Re: Notice of Preliminary Decision - Authority to Construct
Facility Number: S-1807
Project Number: S-1143485

San Joaquin Valley Air Pollution Control District
Authority to Construct Application Review
Reconfigure Tank Battery, Convert Wash/Stock Tank to Stock/Wash Tank

Facility Name: E&B Natural Resources Mgmt Date: September 22, 2014
Mailing Address: 3000 James Road Engineer: Richard Edgehill
 Bakersfield, CA 93308 Lead Engineer: Steve Leonard
Contact Person: Shams Hassan and Scott Faulkenburg
Telephone: (661) 616-6168 (SH) and (661) 345-8263 (cell, SF)
Fax: (661) 616-6179
E-Mail: sfaulk@global.t-bird.edu
Application #(s): S-1807-25-2 and '-71-0
Project #: 1143485
Deemed Complete: August 28, 2014

Pre- and Post-Project Facility Diagrams

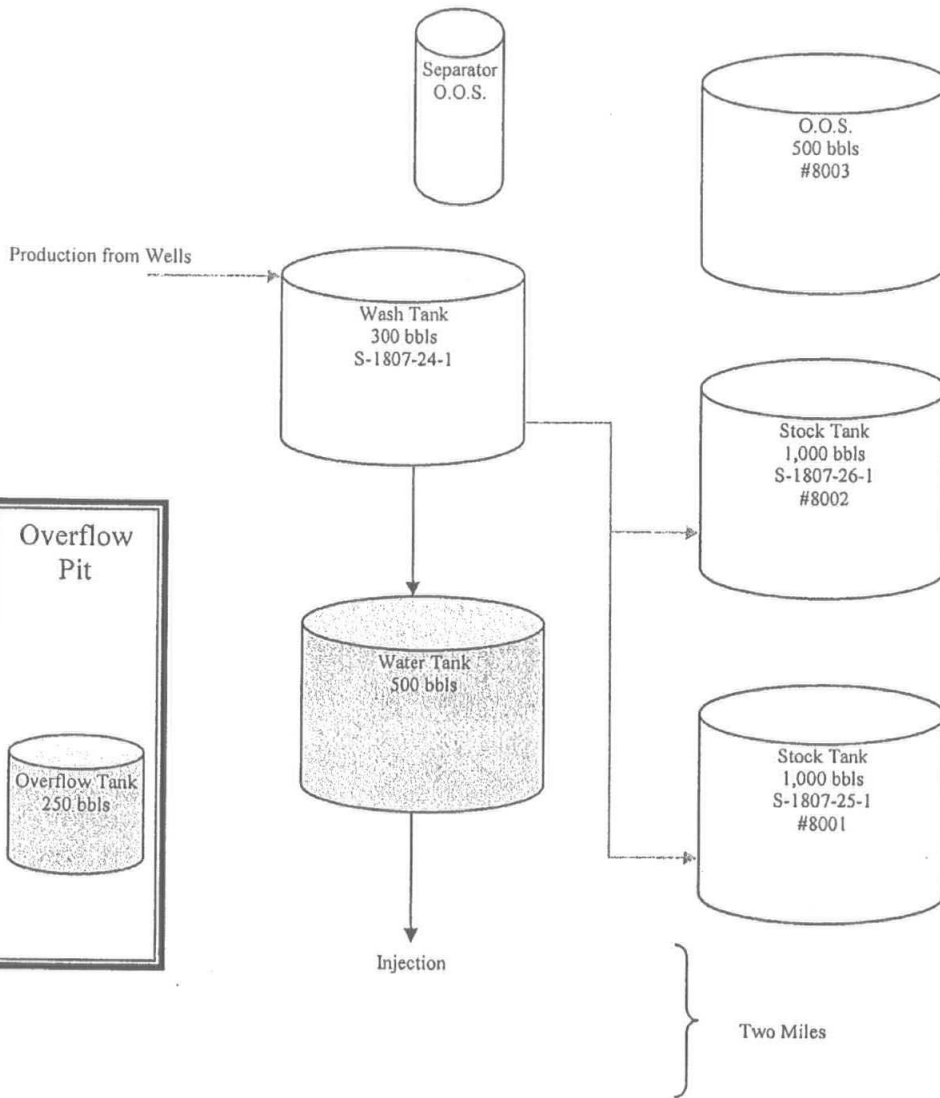
Stock tank S-1807-25 will be converted to a wash tank (with flashing losses). Pre- and post-project facility diagrams are included in **Attachment II**.
